July 30, 1993  
JPN-93-054

SUBJECT: James A. FitzPatrick Nuclear Power Plant  
Docket No. 50-333  
**Response to Request for Additional Information Regarding  
Proposed Technical Specifications Change for a One-time  
Extension to Various Surveillance Intervals**

**Attachment to JPN-93-054  
Page 1 of 7**

Figure 1  
**SRV Setpoint Drift**  
(1983 - 1992)

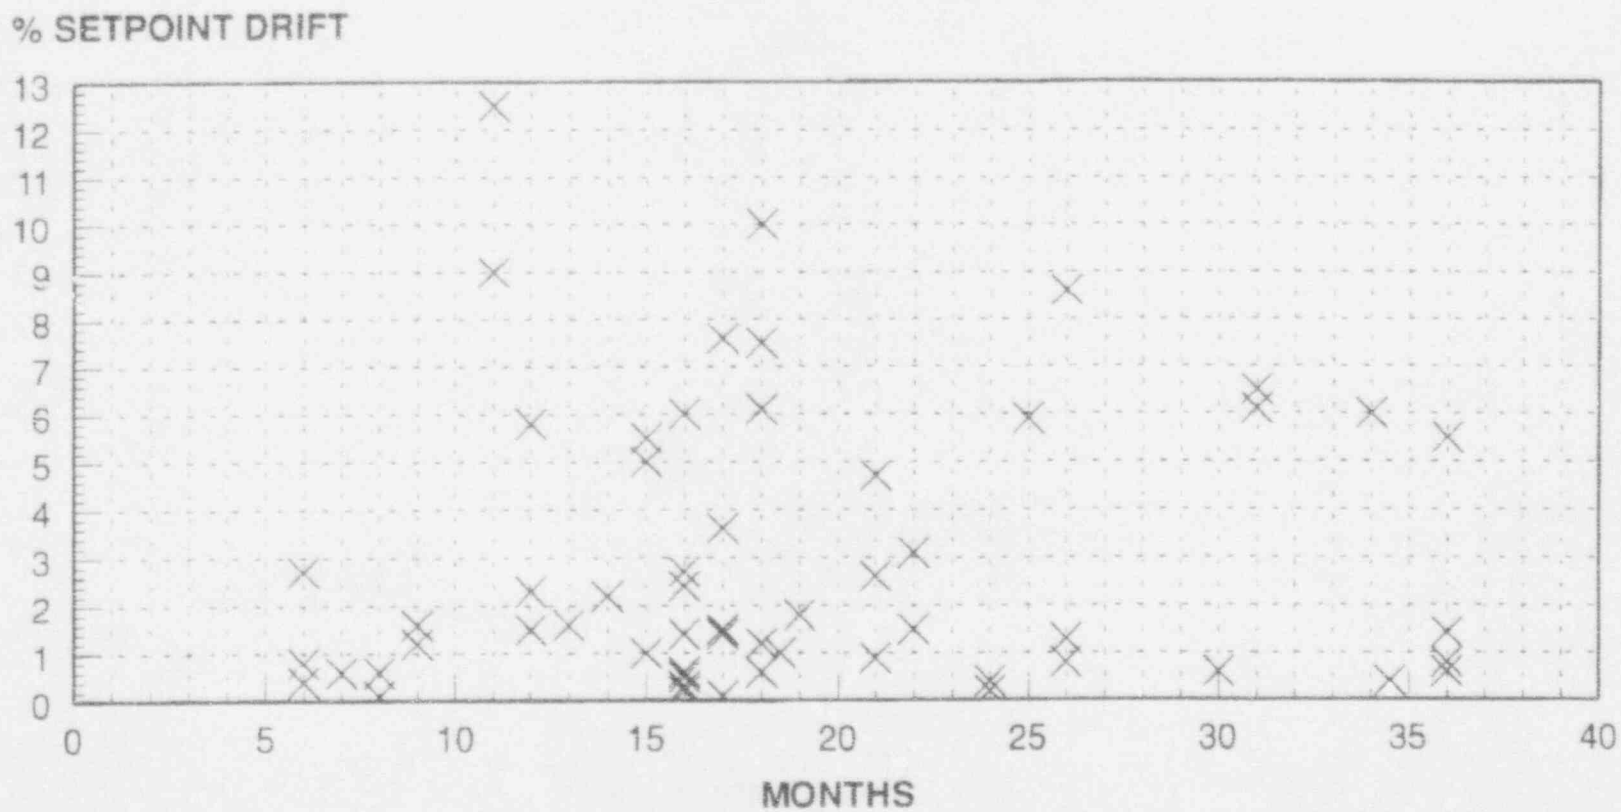
The submittal stated that the plant Target/Rock 2-stage SRVs have experienced significant setpoint drift. The staff has also received similar information regarding significant setpoint drift at other plants. Have there been circumstances similar to those at FitzPatrick where Target/Rock 2-stage SRVs were not tested for extended periods of time, and how were those SRV setpoints affected for the extended periods?

The SRVs are required to open within 1% of the specified setpoints. SRV setpoint drift has caused the setpoint tolerance to be exceeded at the FitzPatrick Plant. A review of setpoint drift data reveals that there is no correlation between SRV installation time and setpoint drift. Figure 1 shows the results of this review. This data represents testing of 20 SRV topwork assemblies which have been in-service at the FitzPatrick plant from 1983 to 1992. The topworks are interchangeable, with each of the eleven SRVs having had several different topworks associated with it. However, each topwork has a unique serial number and has been traced back to the particular SRVs that it had been attached to since 1983.

For this surveillance extension request, the time interval between testing the SRVs is approximately 36 months. For this time frame (~ 34 to 36 months), four topworks had setpoint drifts under 1.5% and two topworks that had setpoint drifts of approximately 5.5% and 6%. There are also instances of topworks installed on SRVs for a short duration that have had very high setpoint drifts. In conclusion, there is no discernable pattern or correlation between time and percent drift.

The Authority has not surveyed other utilities to collect SRV setpoint drift and topwork installation time data. The Authority considers the FitzPatrick SRV setpoint drift data to be representative of industry experience with Target/Rock 2-stage SRVs. For this reason, the Authority concludes that there is no direct correlation between SRV topwork installation time and percent drift.
